Raspberry Pi Compute Module 4 SODIMM

PCN 37 – Alternative sources of RAM

Raspberry Pi Compute Module 4 SODIMM

PCN 51 – Alternative sources of
eMMC

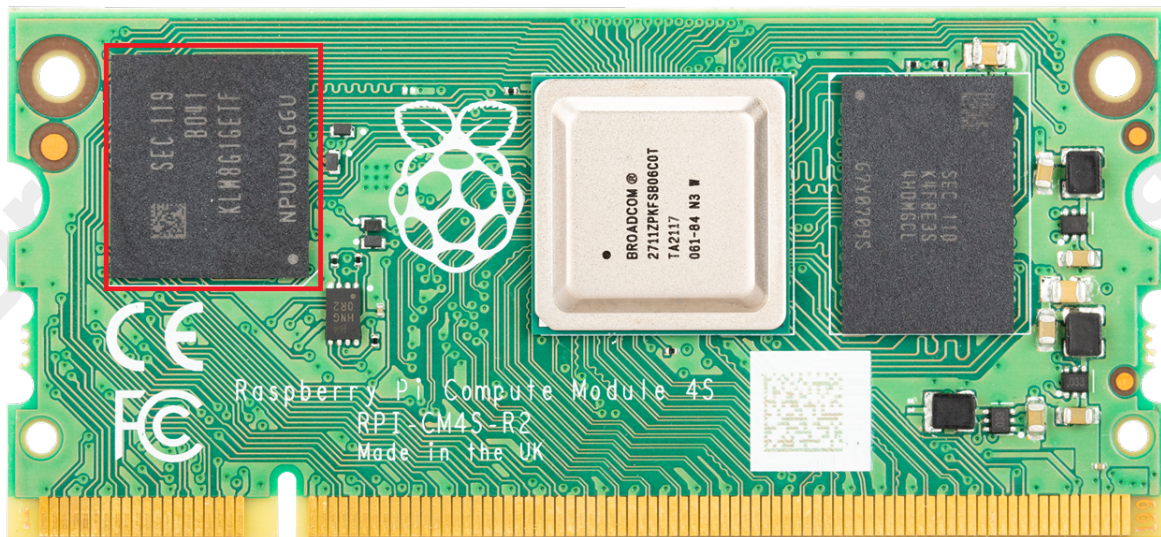
Identification Method to Distinguish Change

The new product can be distinguished by examination of the eMMC device, highlighted in the following image.

Manufacturer	Part number	Size	Type
Rayson	RS70B08G3S03F	8GB	MLC
Rayson	RS70B16G4M15G	16GB	MLC
Foresee	FEMDNN064G-C9A61	64GB	TLC
